The Coalition on West Valley Nuclear Wastes

Comments

*Draft Environmental Impact Statement for Decommissioning and/or
Long-Term Stewardship at the West Valley Demonstration Project and
Western New York Nuclear Service Center
(DOE/EIS-0226-D [Revised])*

Figure 1

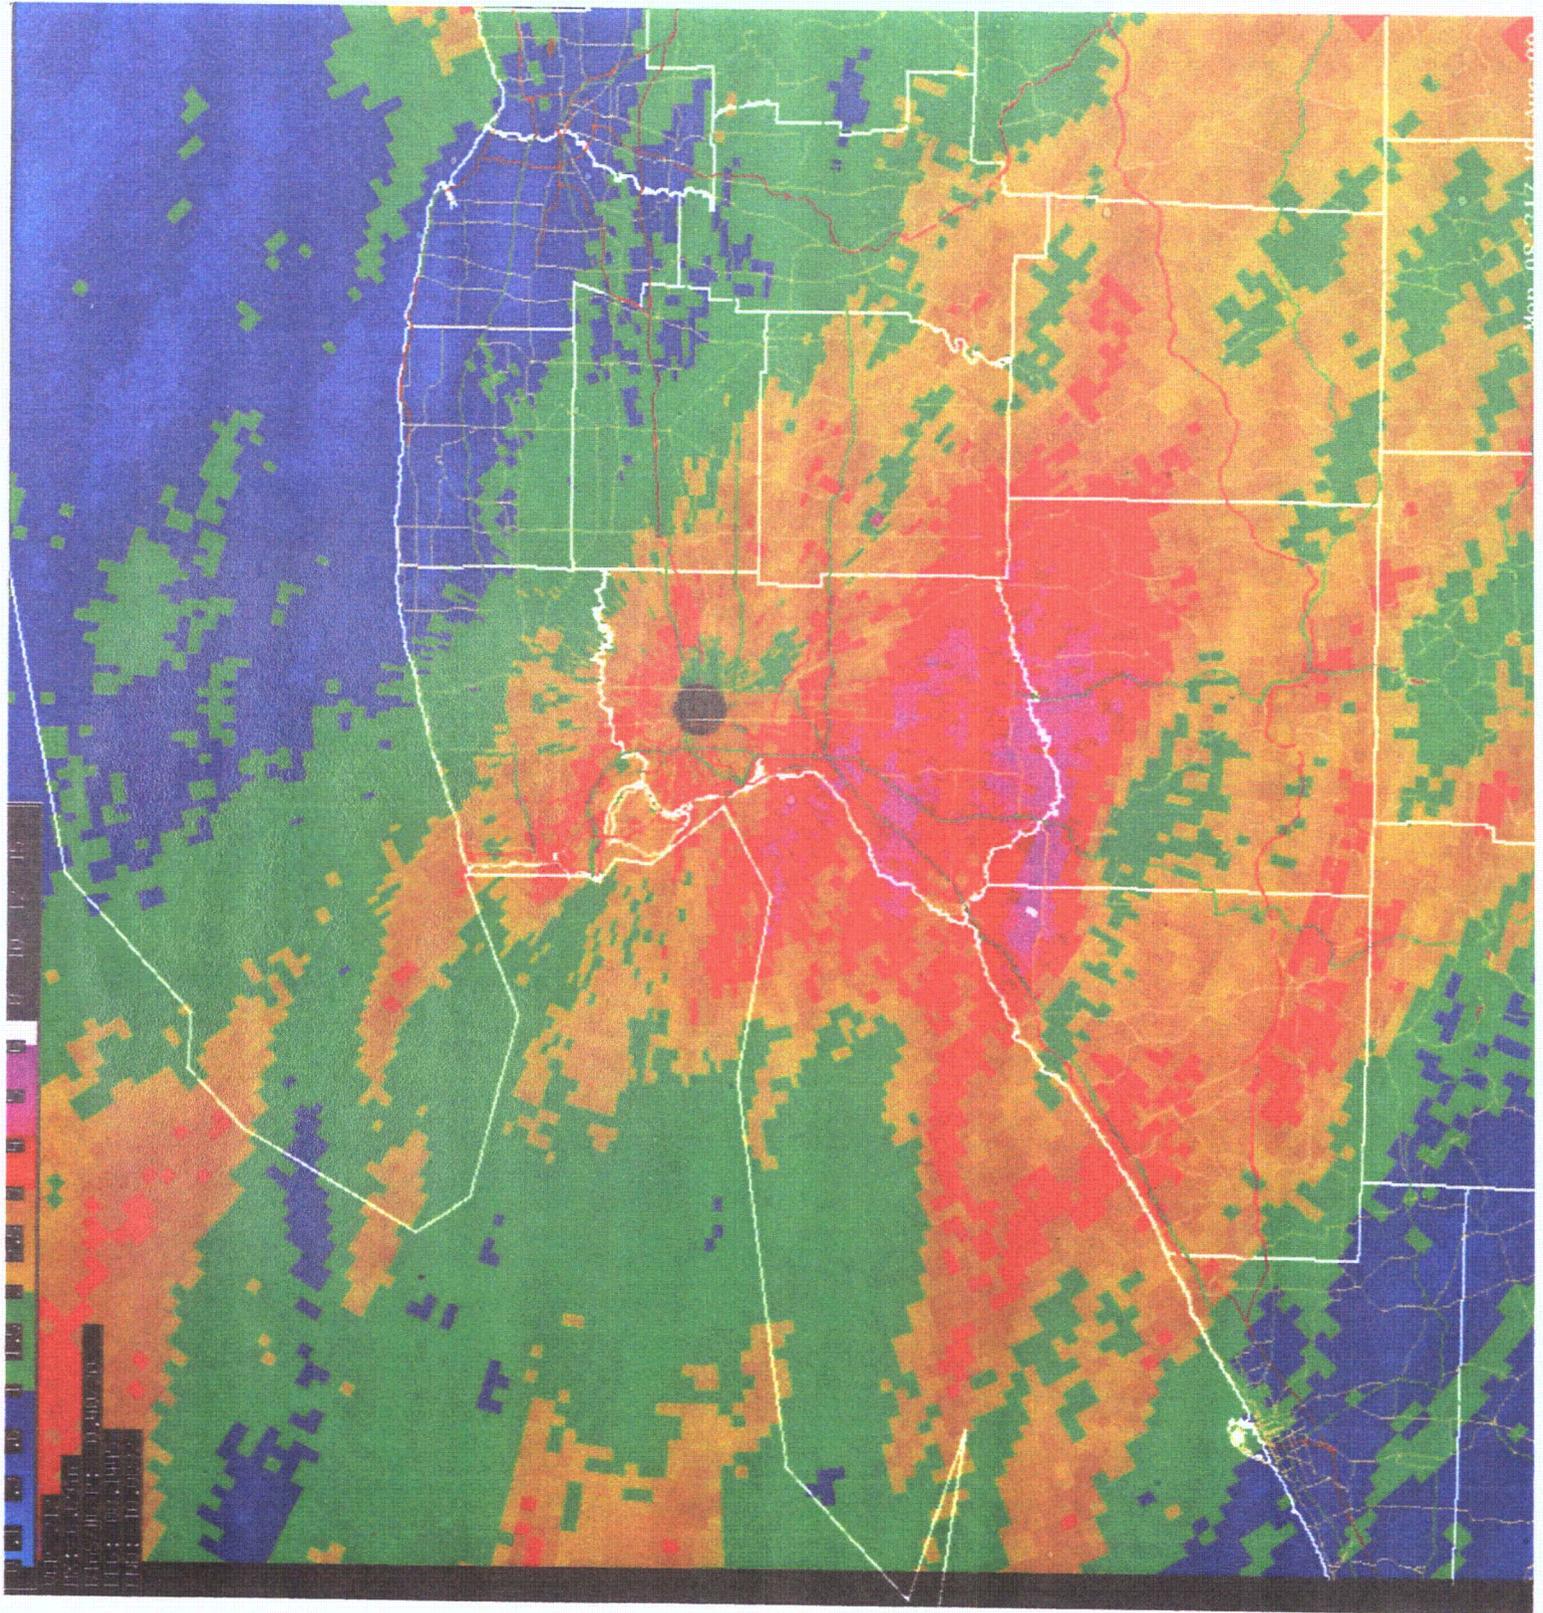
While the Perrysburg spotter's data are impressive, the uncorrected NWS Buffalo doppler radar storm total image indicates that the greatest rainfall total, and likely greatest intensities, for this 3-day event occurred in an area (the gray rectangle) centered on the intersection of Hopper and Hanover Roads near the Silver Creek Reservoir in Chatauqua Co., approximately 5 miles west of the Perrysburg spotter's location, where possibly just under 9" total fell (using nearby Perrysburg +1" ground truthing adjustment of the doppler estimate). See **Figure 1**, attached. The Perrysburg spotter's three-day total was 7.87 inches, and her August total was 13.08" (normal is ~4").

MODIS full color Image at 2:05PM EDT August 13, 2009, 3 days after the floods. Turbidity plumes are clearly evident in the lighter green colors on the east end of Lake Erie as well as the mouth of the Niagara River where it empties into Lake Ontario.

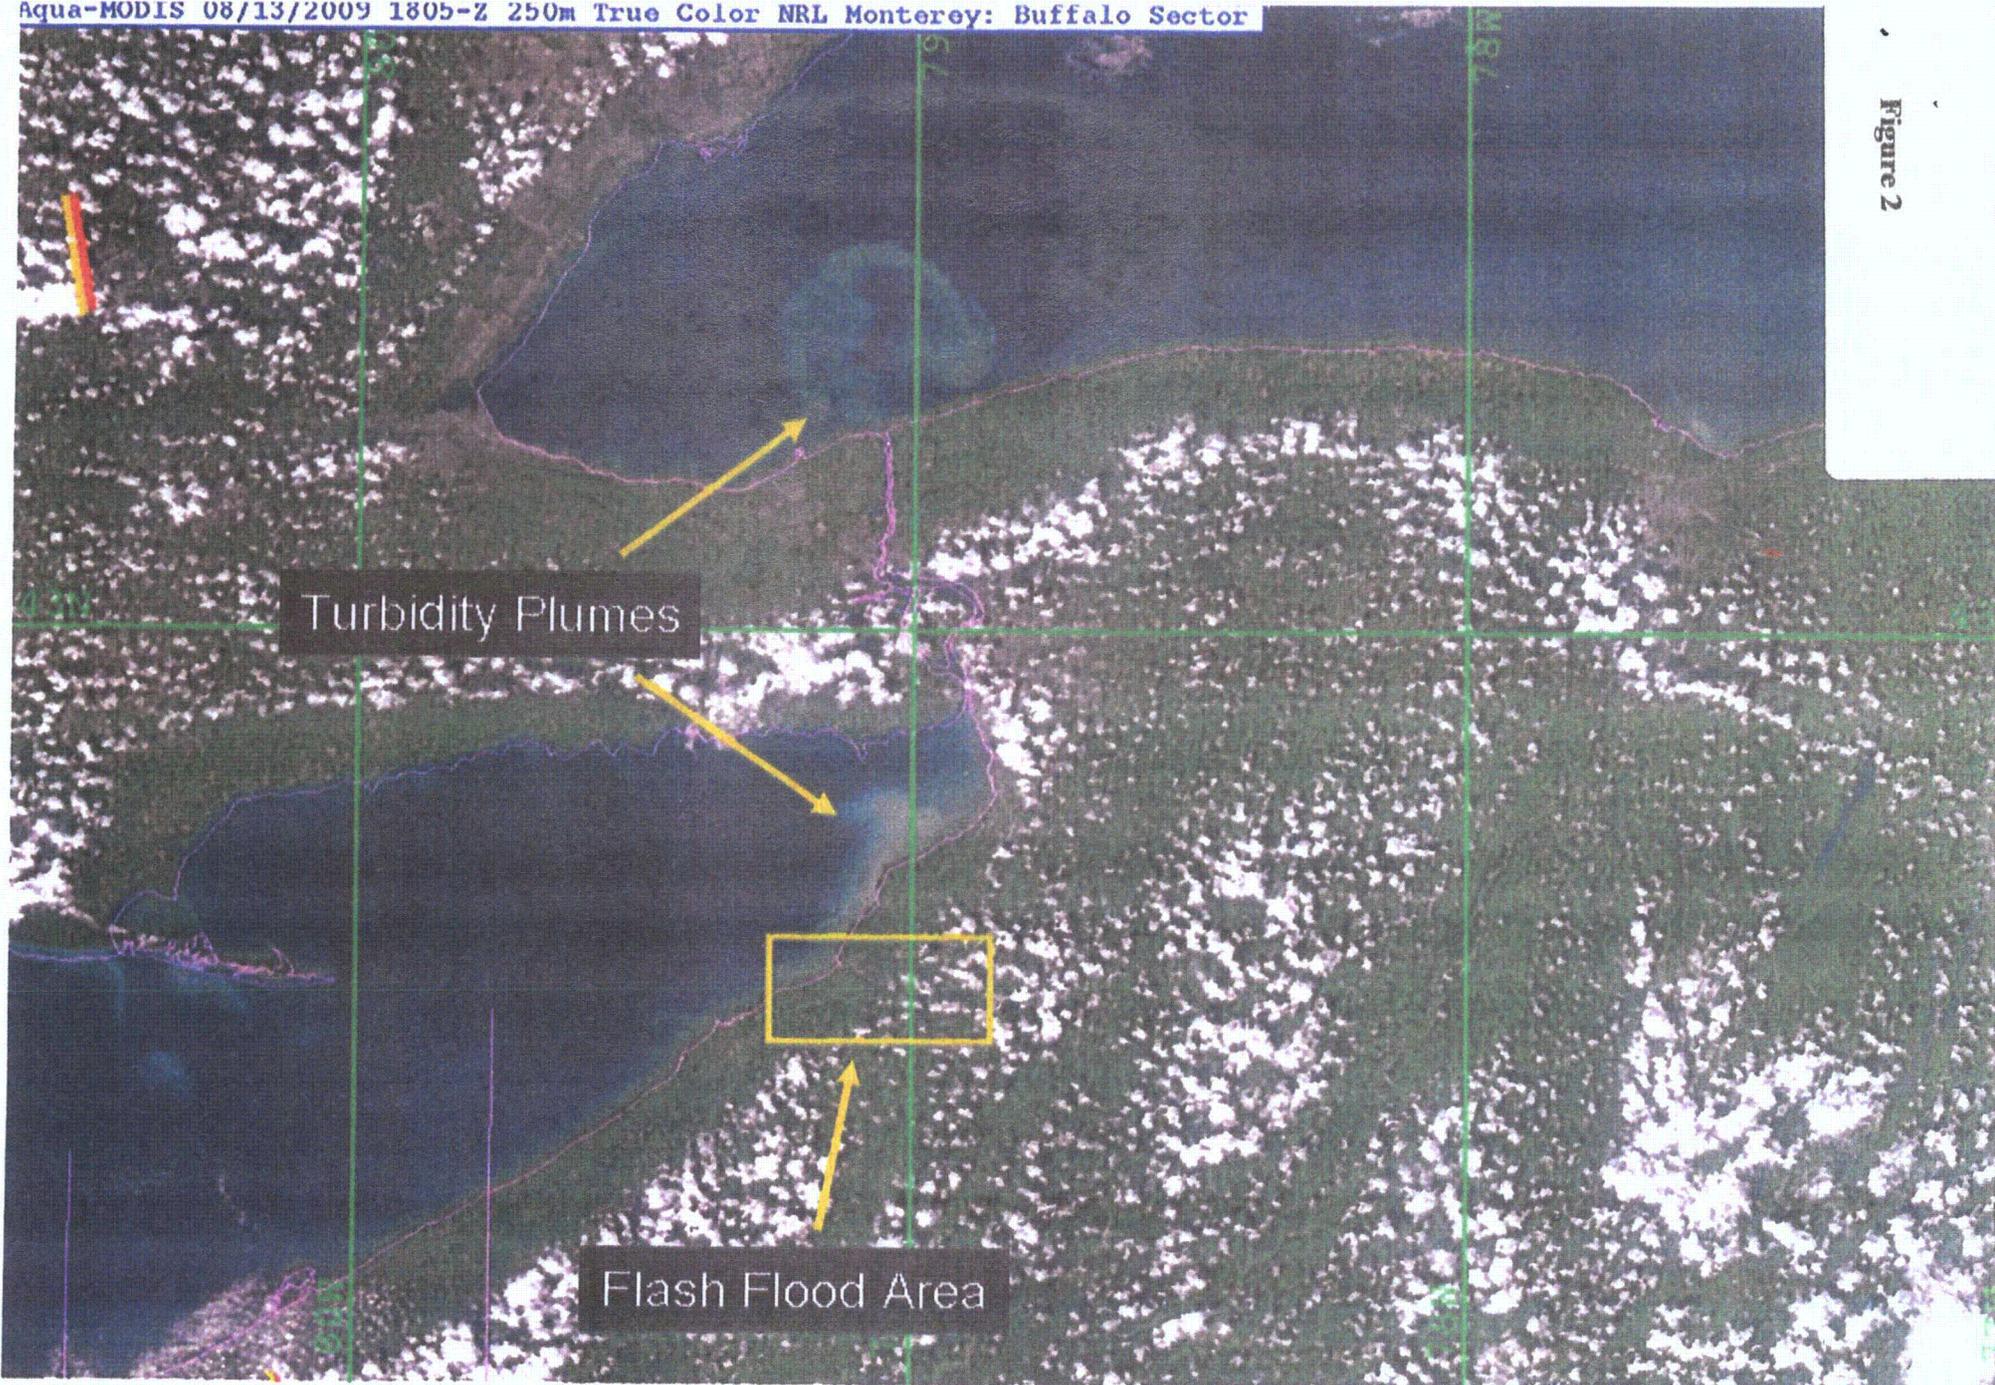
The flood event summary contains satellite photos that show the massively soil-laden runoff plumes from Cattaraugus Creek and Eighteen Mile Creek (and other smaller creeks) extending out into Lake Erie and eastward to Buffalo, down the Niagara River, and out into Lake Ontario. See **Figure 2**, attached. These photos demonstrate one example of the expected flow patterns that radioactive wastes from West Valley will take when the inevitable breaching of West Valley's waste facilities occurs. No opportunity for disagreement about computer simulations and predictions, just a real-world demonstration provided free of charge by "Mother Nature."
